**TOWN OF HERNDON, VIRGINIA
ARCHITECTURAL REVIEW BOARD WORK SESSION AGENDA
JULY 06, 2022
HERNDON MUNICIPAL CENTER
LARGE CONFERENCE ROOM, 2nd Floor
777 LYNN STREET
7:30 P.M.**

Title: ARB #22-013; New signage; 625 Elden Street

Subject: Pre-application ARB Discussion Item, DP #21-01, 555 Herndon Parkway

2.0 Elevation: LED Illum. S/F Monument
Scale: 3/4" = 1'-0"

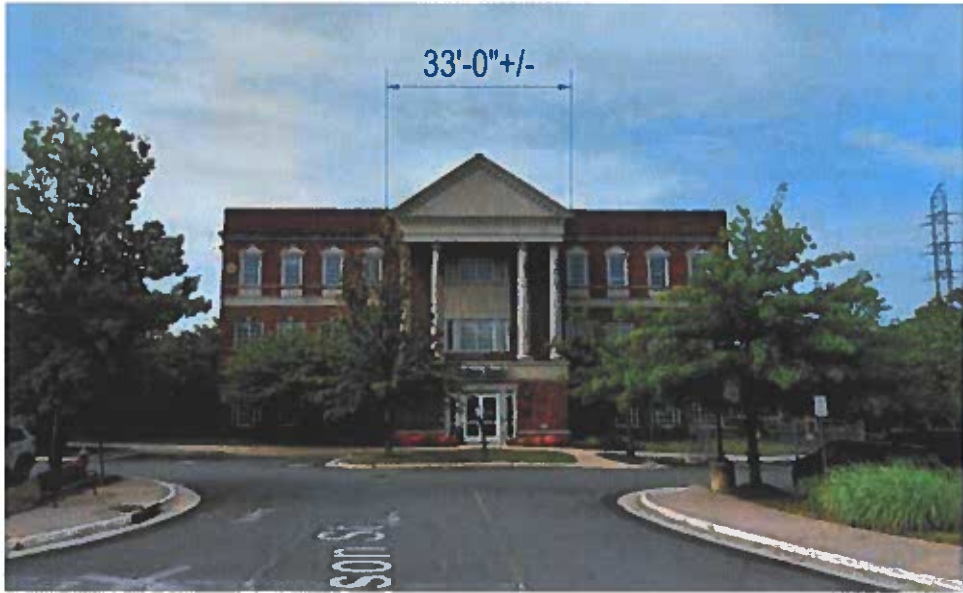
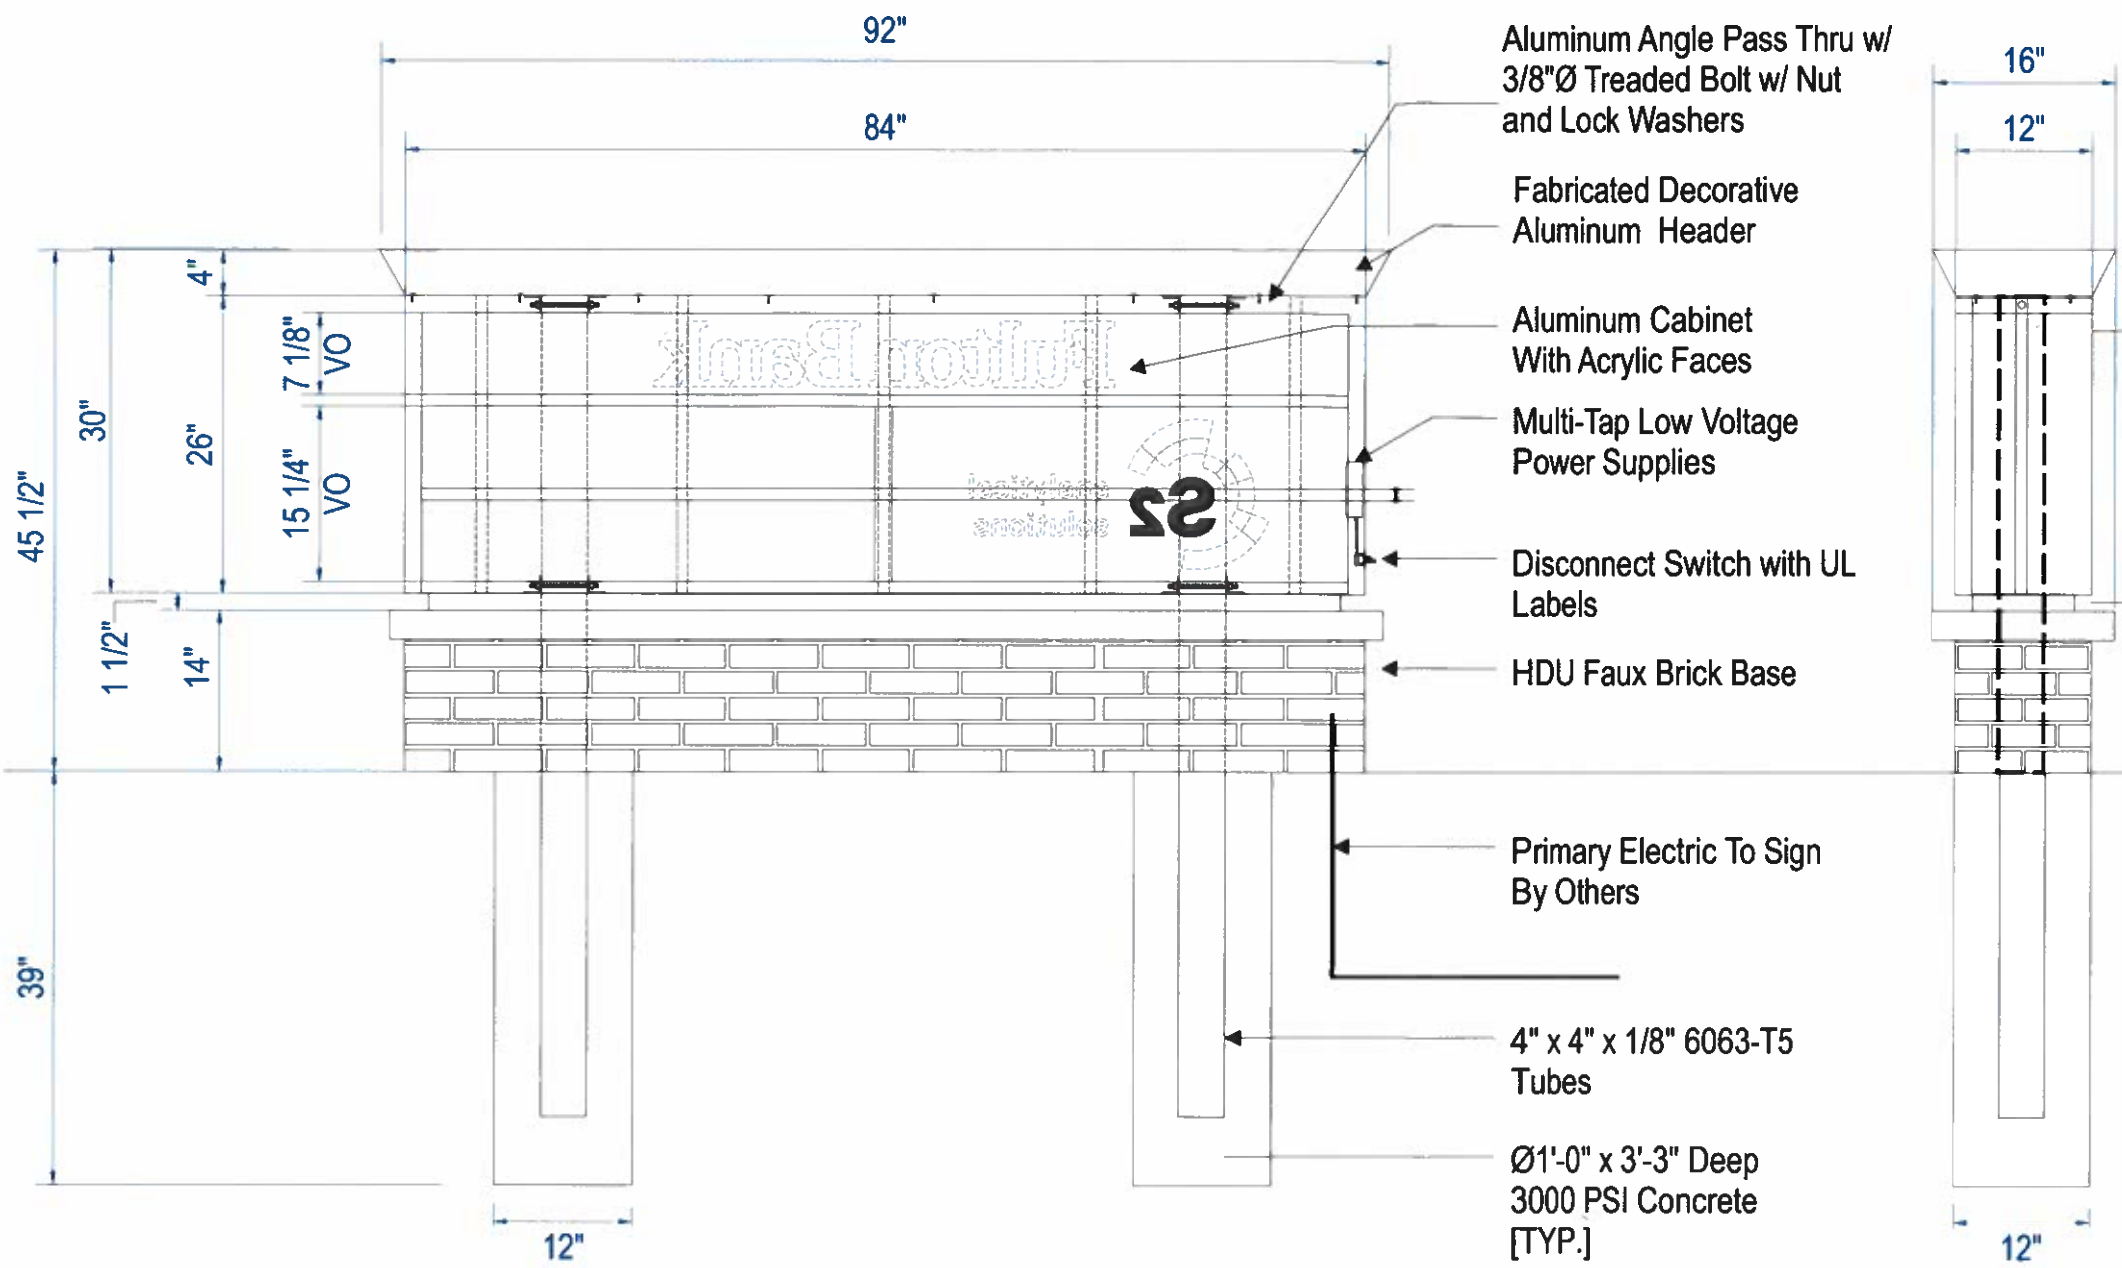
This application is for two business identification signs, one monument sign and one wall sign at 625 Elden Street. The monument sign requires a site plan prior to a review by the board, and therefore is not addressed in this staff report. Following site plan approval, the applicant may re-apply to the board for a review of the monument sign.

- 1) This approval excludes the monument sign portion of this application.

4.0 Elevation: Non-Illum. Pan Sign Qty. = 1
Scale: 1:4

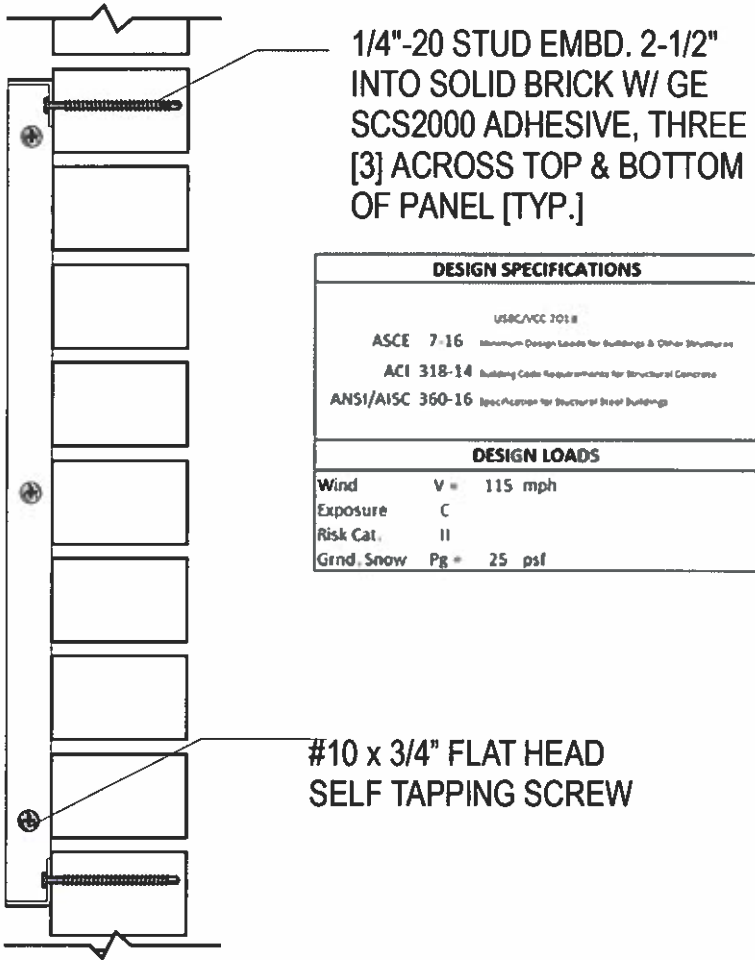
The proposed wall sign may be reviewed by staff, and as such is the subject of this staff report. The sign encompasses 4.5 square feet and has a sign face of non-illuminated painted aluminum with digitally printed vinyl graphics and text. The proposed sign is

flush mounted to the brick façade using aluminum angle clips with masonry anchors. The prospective location of the sign is to the right of the primary entrance to the building. The background of the sign is white and contains a logo and the words “analytical solutions” in red text. The logo and text are digitally printed in vinyl and adhered to the sign face.

1. Staff has found that the proposed signage meets the applicable standards and requirements of the Town of Herndon Zoning Ordinances.
2. With the findings expressed below, staff believes the proposed signage generally complies with the applicable design criteria within the Town’s Architectural Control District as specified in Section 58-96 of the Town Code of Ordinances.

MONUMENT SIGN

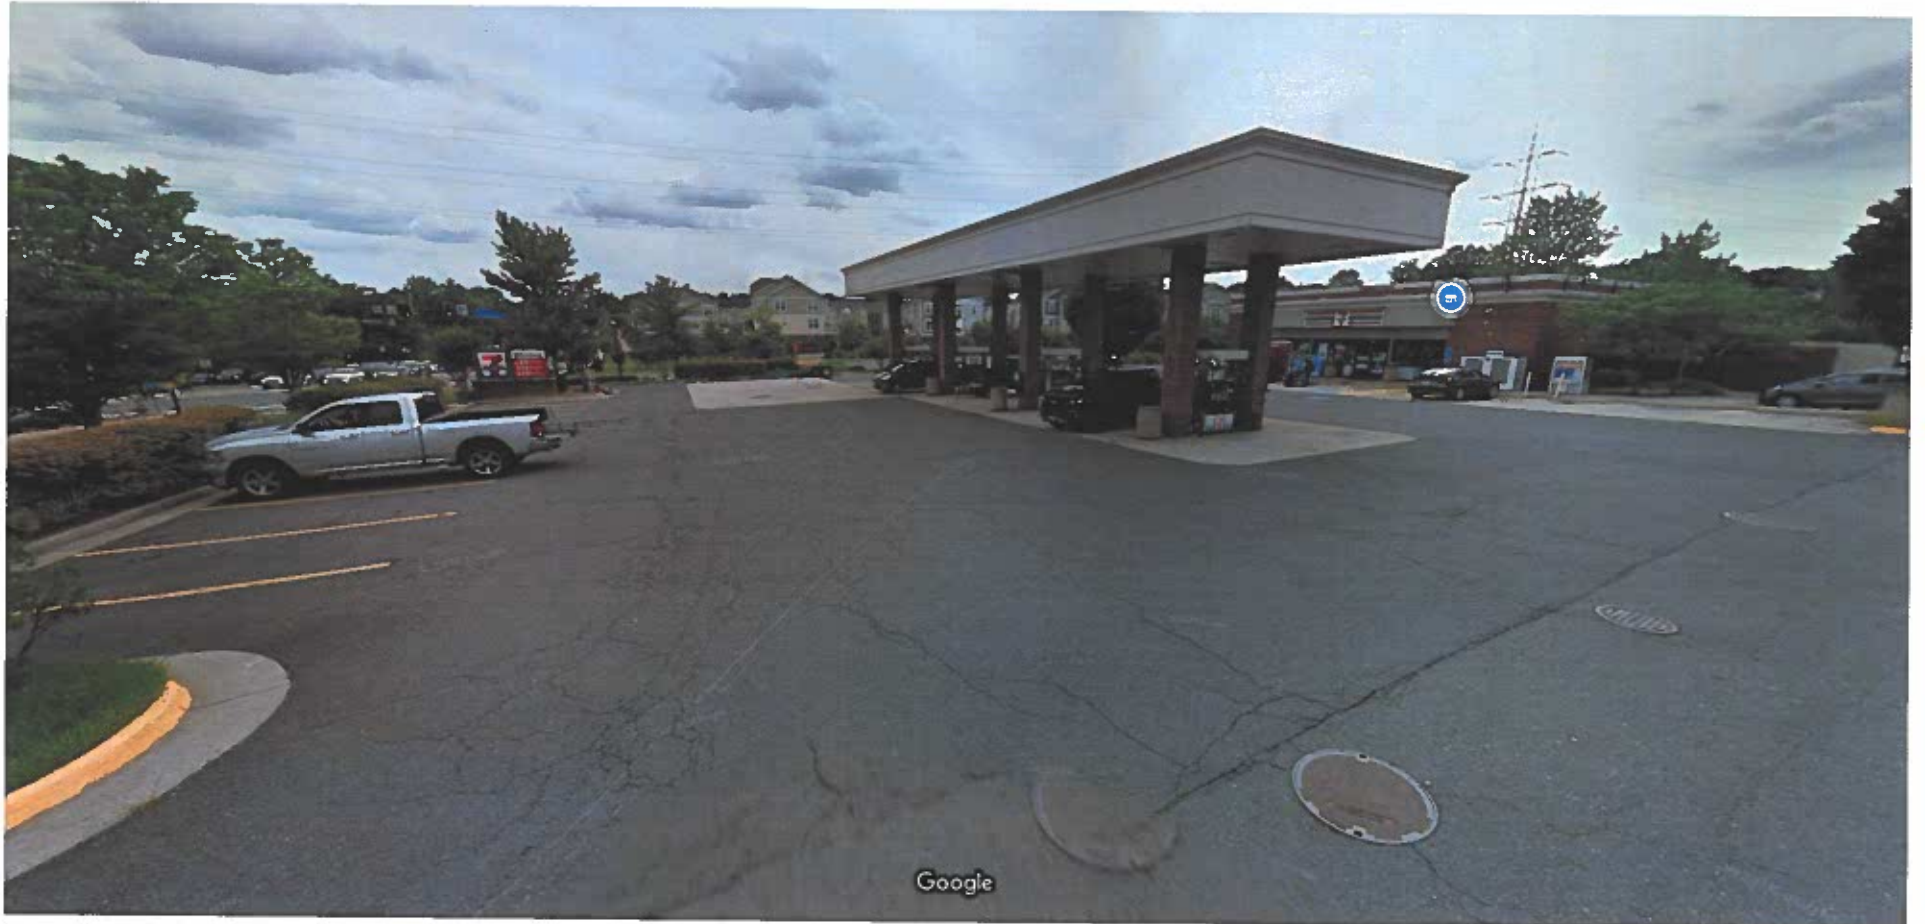
This application is for alterations to an existing monument sign at 700 A Monroe Street. The existing monument sign has a brick masonry base topped with cabinet sign. The sign is divided into two sections, the left portion displaying the branding for 7 Eleven, and the right portion listing gas prices. This application proposes replacing the right-hand portion of the sign which displays gas prices with a digital price display.

1. Staff has found that the proposed signage meets the applicable standards and requirements of the Town of Herndon Zoning Ordinance. The Zoning Ordinance prohibits the use of digital signs for animated, flashing, or frequently changing content. This sign, as proposed, changes infrequently and is generally static.
2. With the findings expressed below, staff believes the proposed signage generally complies with the applicable design criteria within the Town's Architectural Control District, as specified in Section 58-96 of the Town Code of Ordinances.
 - a. The proposed sign alteration does not detract from the existing sign or its integration with the surrounding buildings. It is harmonious in materials, color, and aesthetic.
